Date: September 7, 2023  
To: TRPA Hearings Officer  
From: TRPA Staff  
Subject: Single-Family Residential Rebuild for North Shore TVCA LLC,  
6650 North Lake Boulevard, Tahoe Vista, Placer County, CA; Assessor's Parcel  
Number (APN): 117-072-006; TRPA File No.: ERSP2023-0707

**Requested Action:**

**CIVIL AND BMP DETAILS**  
**ROADSTER, LLC**  
 6650 NORTH LAKE BOULEVARD  
 APN 117-072-006  
 PLACER COUNTY  
 TAHOE VISTA

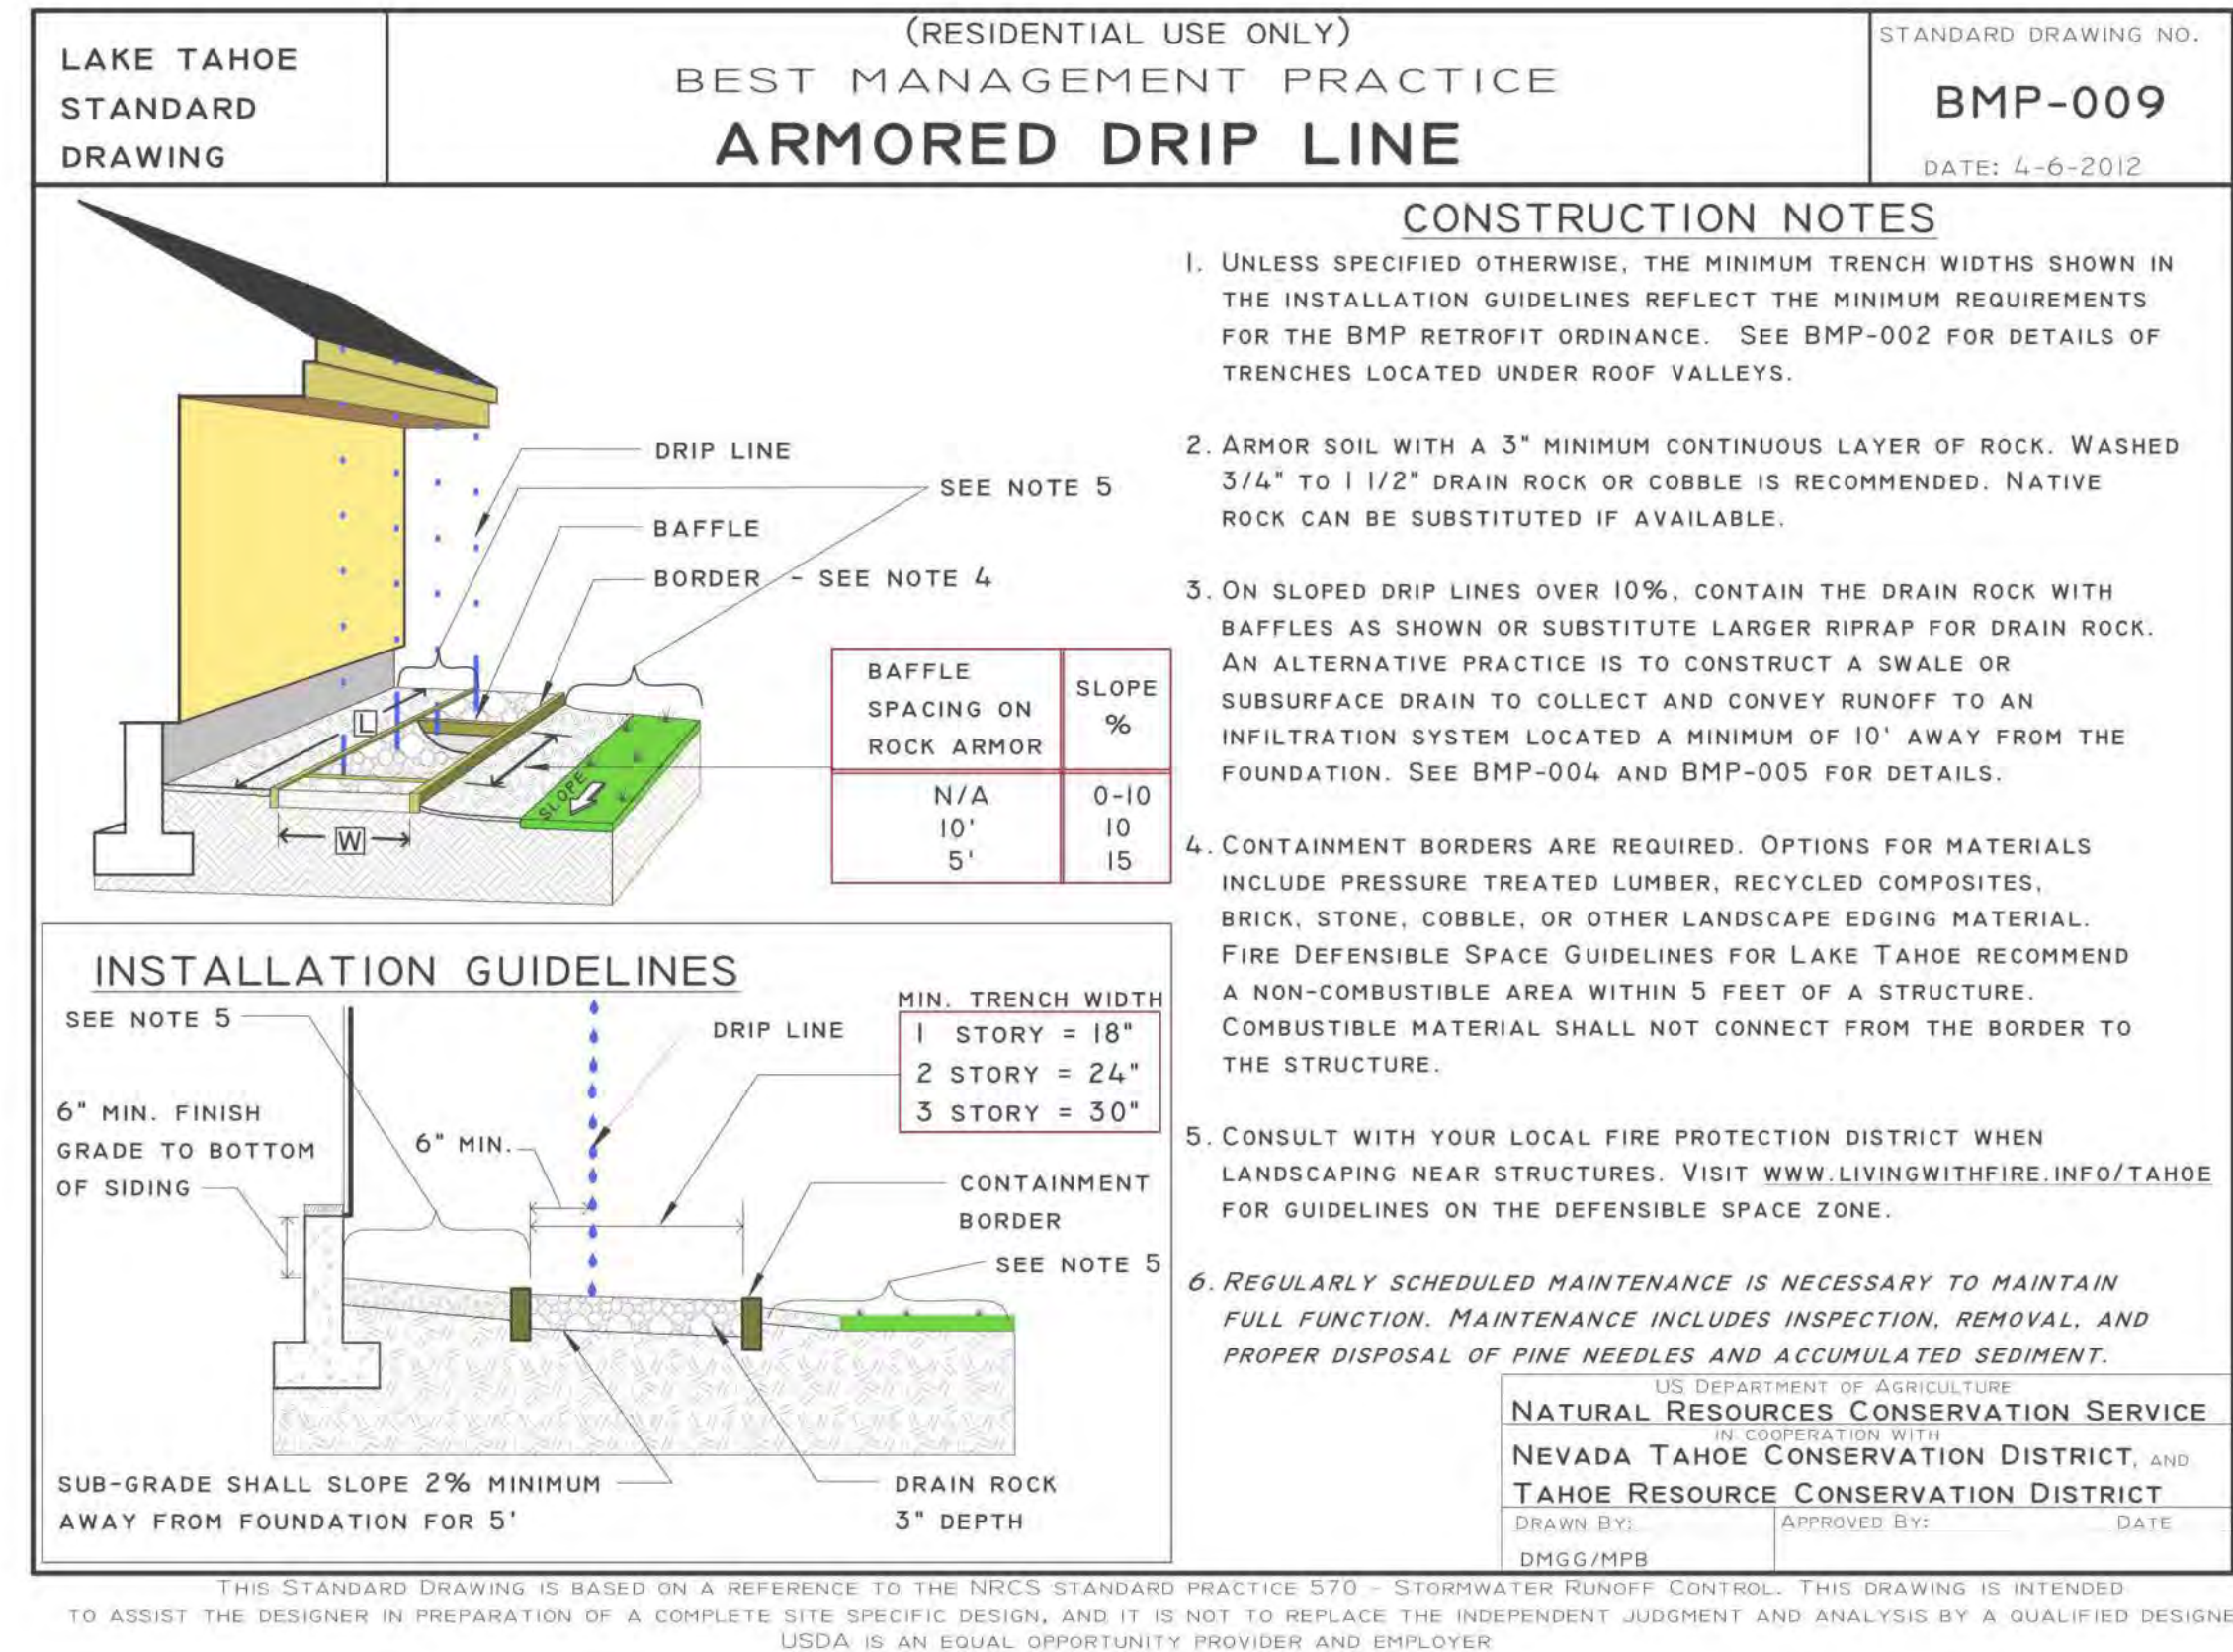
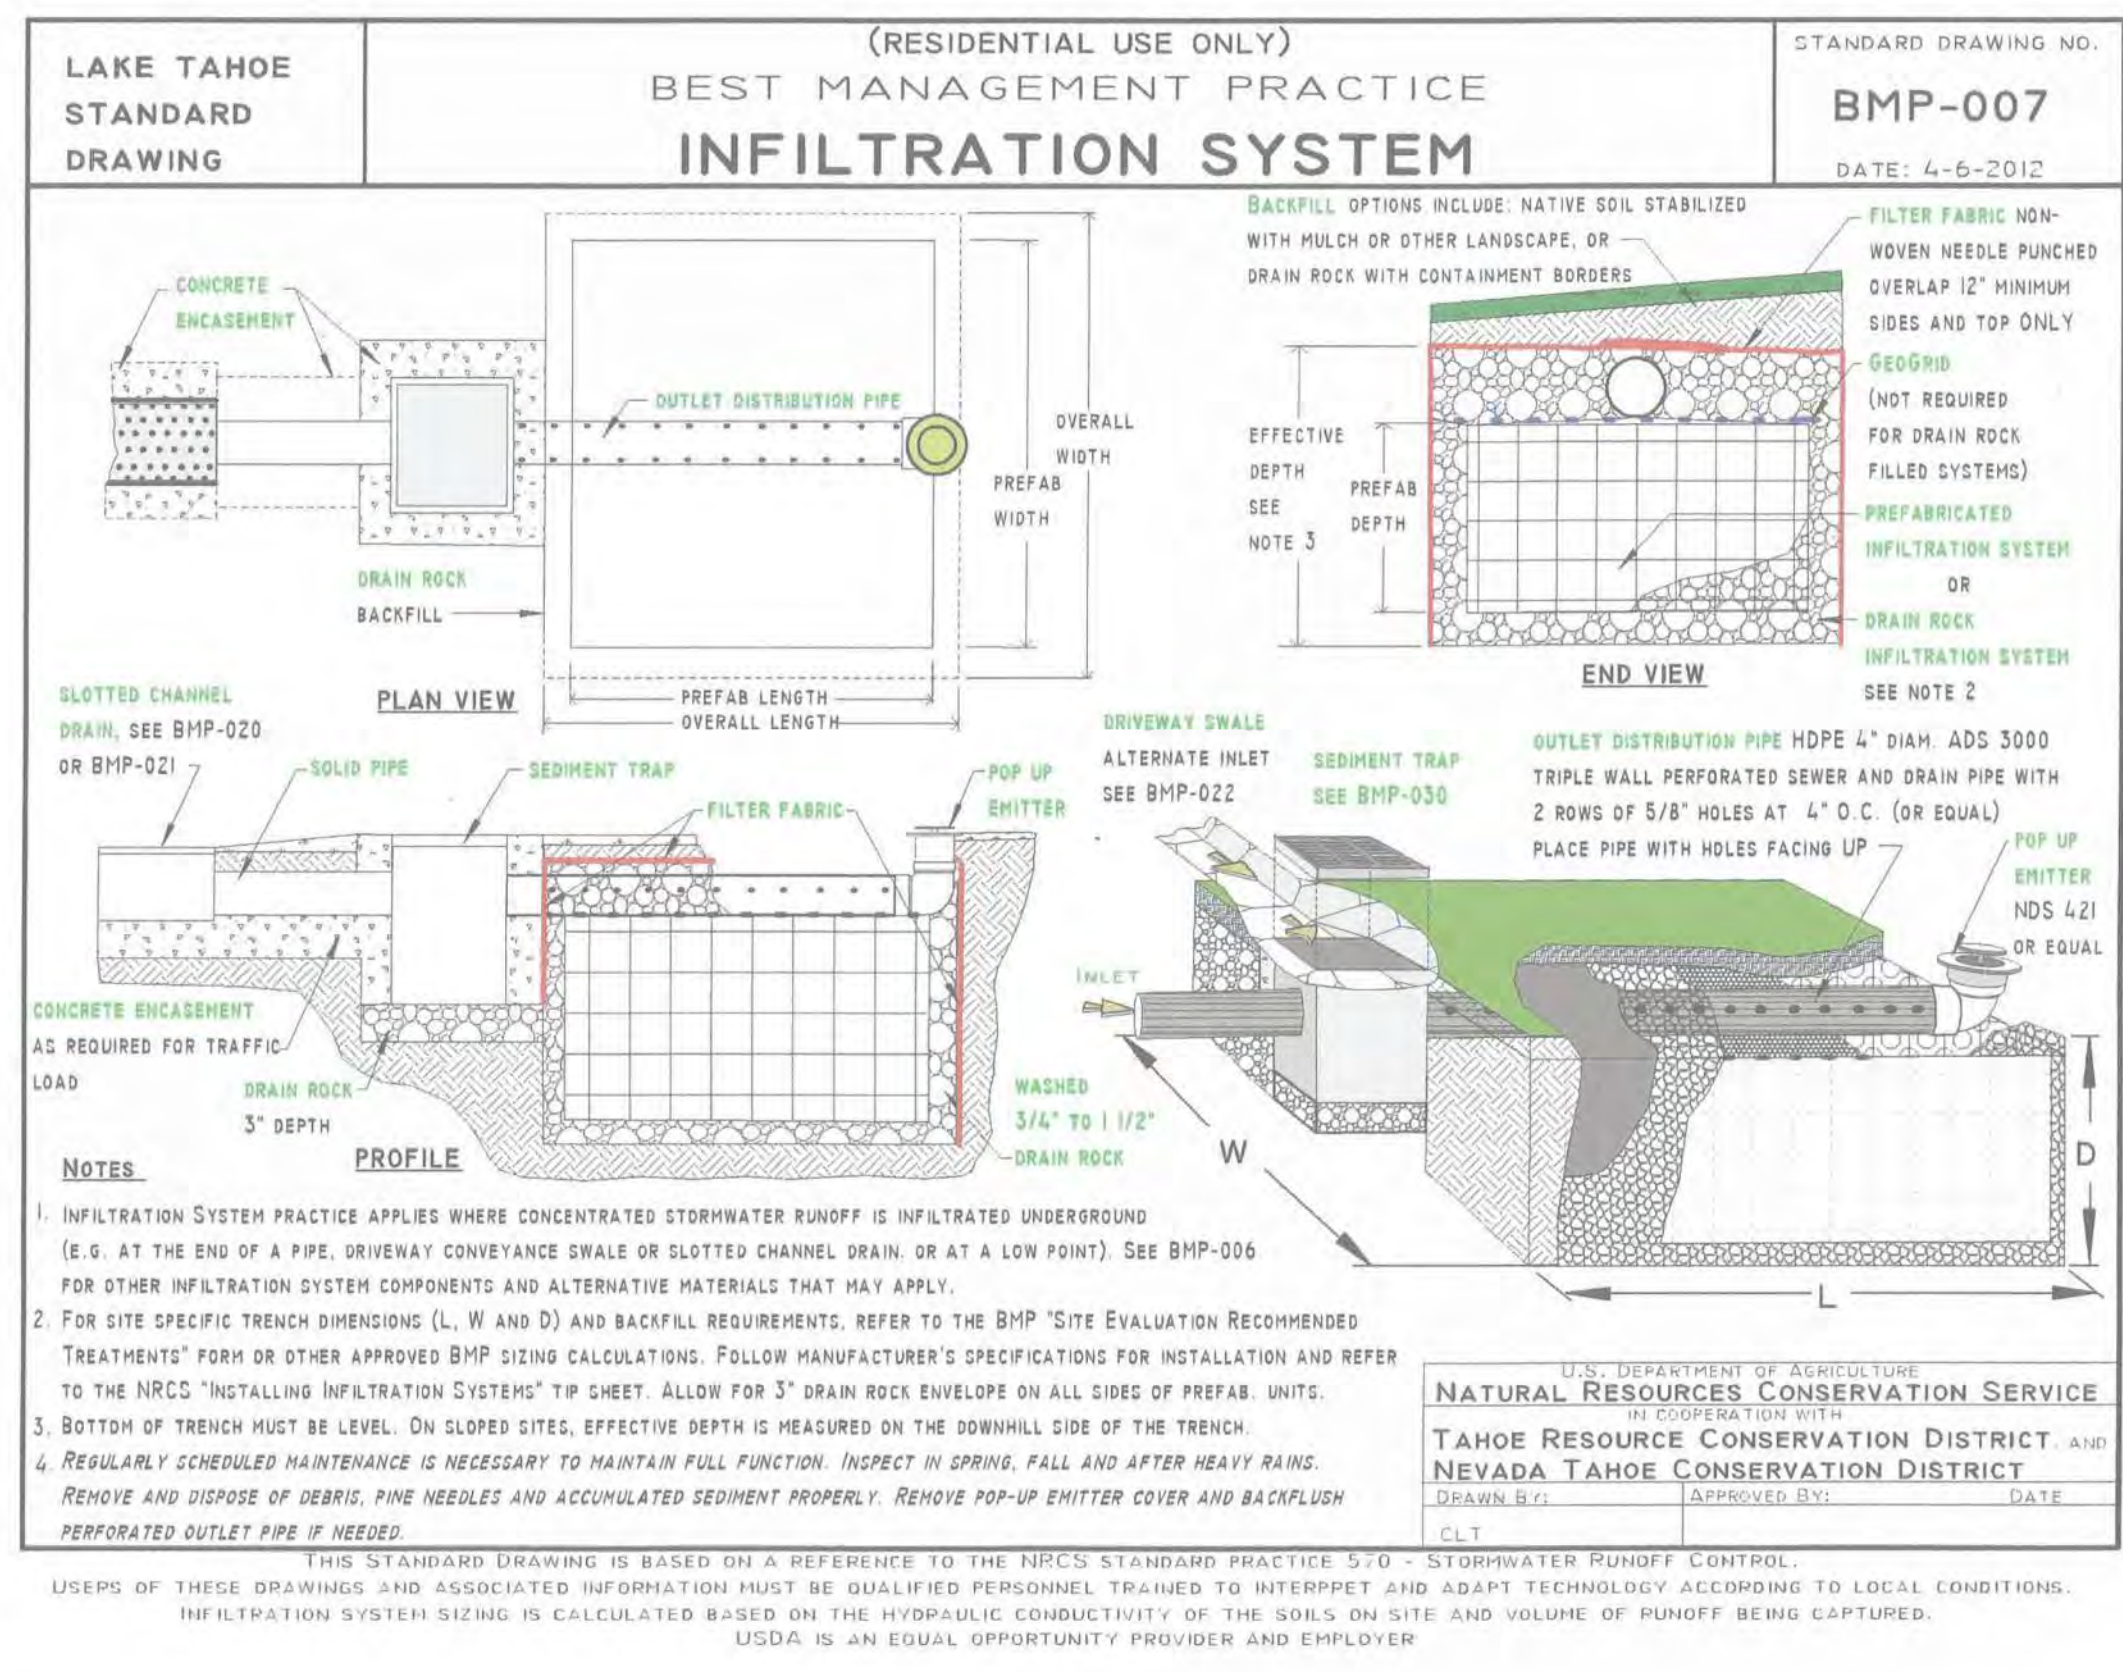
- (10) Enhance driveway BMPs with 3 cleanable sediment traps (detail 2/C2.2) located at 2 points along treatment P and where treatments P and M meet. Provide driveway edge armor (3 inch deep by 12 inch wide infiltration trench or suitable alternative) adjacent to the driveway edges that do not have BMP treatments. Expand armor width to the toe of slopes adjacent to the driveway.
